From: [Linda Stedjee](#)
To: Harris_Ken@Waterboards
Cc: Packard_Harvey@Waterboards
Subject: More concerns with RWQCB staff's April letter
Date: Saturday, May 10, 2014 8:45:30 AM

Going back over Mr. Thomas' letter to Mr. Packard, I have identified a couple more areas of concern. I want to share these additional concerns with you prior to the May 22 meeting.

**Figure 1
MTBE Concentration maps
First Quarter 2005
City of Morro Bay**

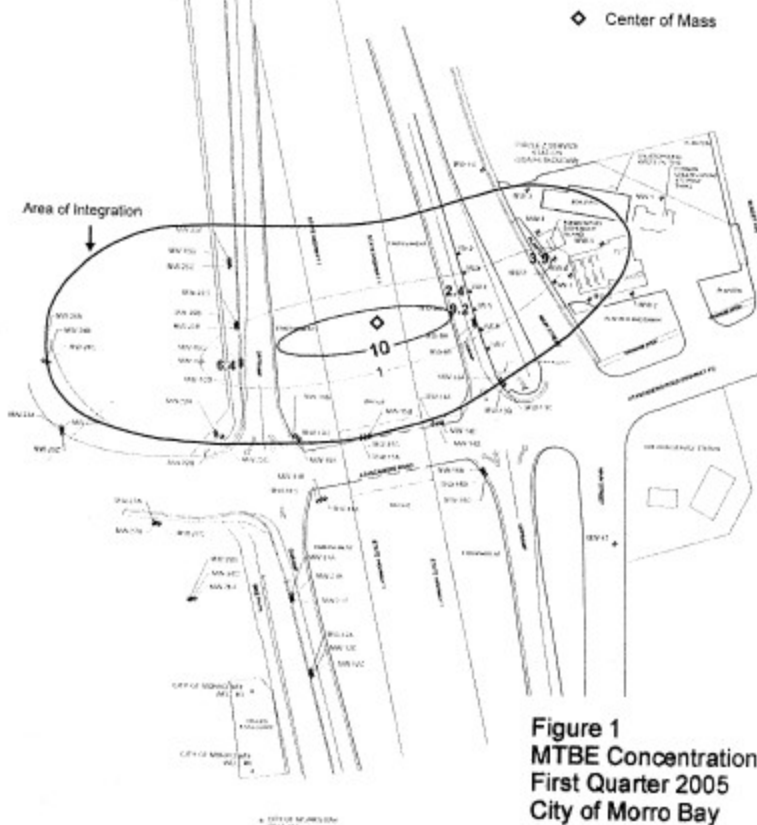
Mr. Thomas does not appear to have carefully reviewed the diagrams in the Cleath letter and the text that discusses them. The diagram below, for example, shows the contours and center of mass for the large MTBE plume in the groundwater. This is NOT a “finger plume” in a sewer trench. It is a very large area of contamination. I would like to point out the obvious fact that, if MTBE from tanks on the site of the former gasoline station can spread this far, so can sewage leaking from the Main Street trunk line(s).

Please note that at no time did we suggest that the threat of sewage contamination of the wells came solely from exfiltrated sewage in the trenches. We believe that the shallow groundwater and aquifer contamination ranges much farther than that. Please consider this diagram from the Cleath letter. It shows the scope of MTBE contamination.

Cleath was clearly concerned that the cleanup was not complete, and the potential for MTBE to be lurking in the sewer trenches was only PART of his concern. He said of the remediation consultants' work,

"The methodology used for MTBE mass calculation is a simplification of an inherently difficult calculation. The main conceptual problem with the simplified mass calculations is a lack of data near the calculated center of mass, which resulted in a bias toward underestimating the MTBE mass after the plume core moved beneath Highway 1."

Mr. Thomas stated the view that there is not a strong hydraulic connection between the City wells and a particular sewer trench that runs down Atascadero Road. This would not, even if he were correct, even begin to address our concern regarding the potential for exfiltrated sewage to enter the municipal wells. While the sewage might start out in a trench, it is not likely to stay there. The large expanse covered by the MTBE plume, as shown in the diagram above, clearly shows that contaminants in groundwater can travel far.

As for Mr. Thomas' premise that, "the MTBE plume core has not been deflected towards the south by the City's wells", I ask that you consider that concept in light of the above diagram, and this one:

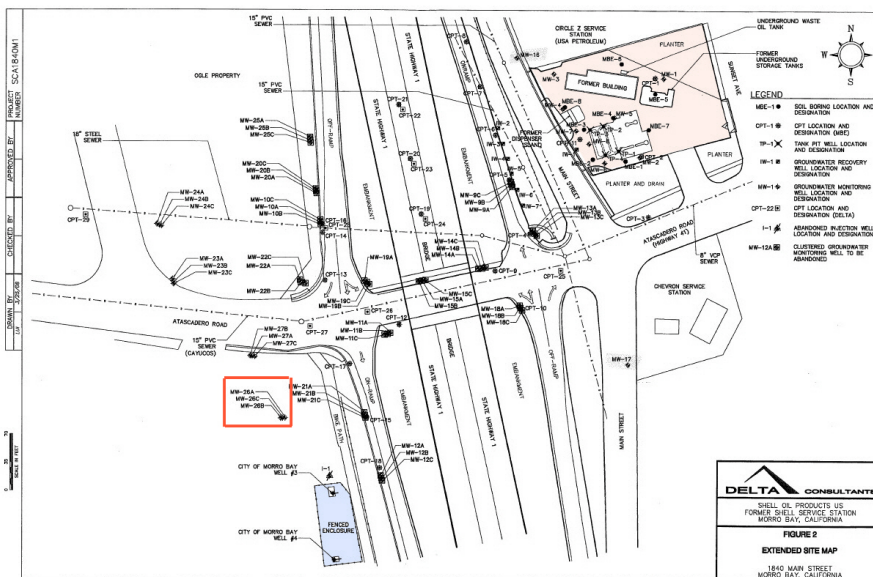
Please note that MTBE was detected in the MW26 cluster, shown by the red box. It is most definitely south of the MTBE plume shown in the diagram above AND it is south of the subject sewer trench that runs down Atascadero Road. Please also recall quotes in my last letter on this subject - quotes indicating that detections in the MW26 well cluster were found to be associated with use of the well field.
